IN THE UNITED STATES PATENT AND TRADEMARK OFFICE

Applicants : Theodore Bydalek, *et al.*
Serial No. : 10/712,611
Filed : November 13, 2003
For : FASTENER ASSEMBLY
Art Unit : 3677
Examiner : JEFFREY ANDREW SHARP

PETITION TO THE DIRECTOR UNDER 37 C.F.R. § 1.181(a)(2)

FIG.30

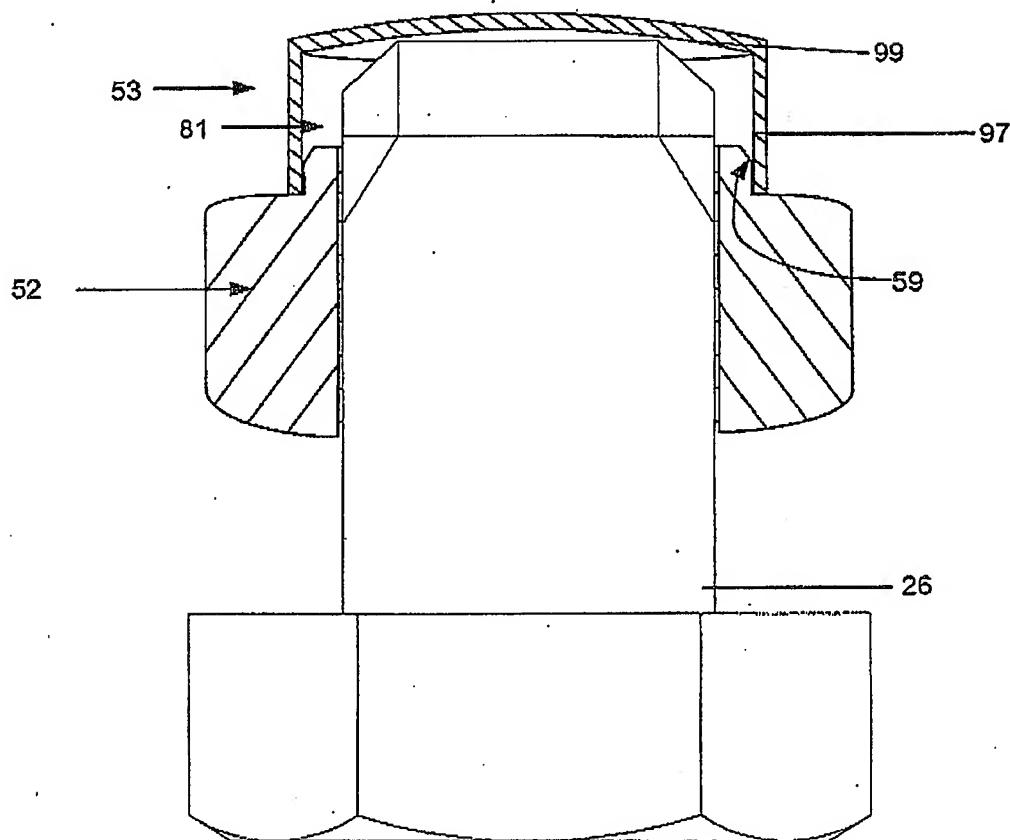
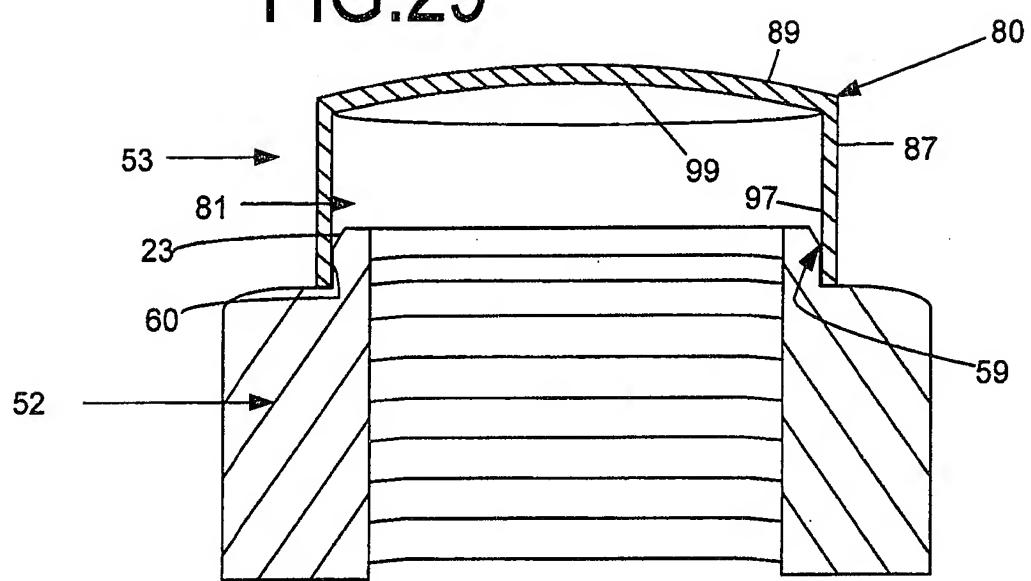
In the Office Action mailed on May 17, 2007, the Examiner objected to Figure 30 on grounds that the spherically shaped annular bearing surface located on the “lower side of the body” constituted new matter. See 05-17-2007 Office Action, Pg. 2, ll. 12-13. Specifically, the Examiner objected to amended Figure 30 under 35 U.S.C. § 132, stating “it [Fig. 30] introduced new matter into the disclosure.” Id. The Examiner further stated:

The added material which is not supported by the original disclosure is as follows: the location of the spherical annular bearing surface on the body was not previously disclosed. Therefore, the new replacement sheet effectively introduces matter, which previously has not been disclosed by illustrating a particular location for the annular bearing surface having a spherically convex shape—said location being a lower side of the body. See 05-17-2007 Office Action, Pg. 2, ll. 14-19.

[3] The drawing(s) were previously objected for informalities. Applicant submitted a replacement sheet on 28 February 2007 to address claimed subject matter (spherically convex annular bearing surface) not shown.

The amendment filed 28 February 2007 is objected to under 35 U.S.C. 132(a) because it introduces new matter into the disclosure. 35 U.S.C. 132(a) states that no amendment shall introduce new matter into the disclosure of the invention. The added material which is not supported by the original disclosure is as follows: the location of the spherical annular bearing surface on the body was not previously disclosed. Therefore, the new replacement sheet effectively introduces matter, which previously has not been disclosed by illustrating a particular location for the annular bearing surface having a spherically convex shape -- said location being a lower side of the body.

The drawing (i.e., Figure 30) was objected to under 37 C.F.R. § 1.83(a). The Examiner pointed out, while admitting the feature is fully disclosed in the specification, that Figure 30 does not include an annular bearing surface on the body that is spherically convex in shape.

In response to the initial request by the Examiner, Applicants, in a good faith, attempted to place the Application in condition for allowance by submitting amended Figure 30. Amended Figure 30 was fully supported by the specification. According to the Specification, the body cooperates with the object being fastened. See 11-13-2003 Specification, Pg. 10, ll. 6-7. As shown in amended Figure 30, the surface that cooperates with the object being fastened is depicted as the annular bearing surface on the body. See 02-28-2007 Amendment, Pg. 23. As such, one of ordinary skill in the art would recognize that the annular bearing surface is located on the “lower side” of the body, as was shown in amended Figure 30.

Applicants submit a Replacement Sheet for the newly amended Figure 30. Per Examiner's suggestion, the amended Figure 30 now includes an annular bearing surface on the body that is spherically convex in shape. The amended Figure 30 is now consistent with the Specification. No new matter is introduced.

Applicants respectfully submit a Replacement Sheet for Figure 30 showing an annular bearing surface on the body that is spherically convex in shape. No new matter is introduced.
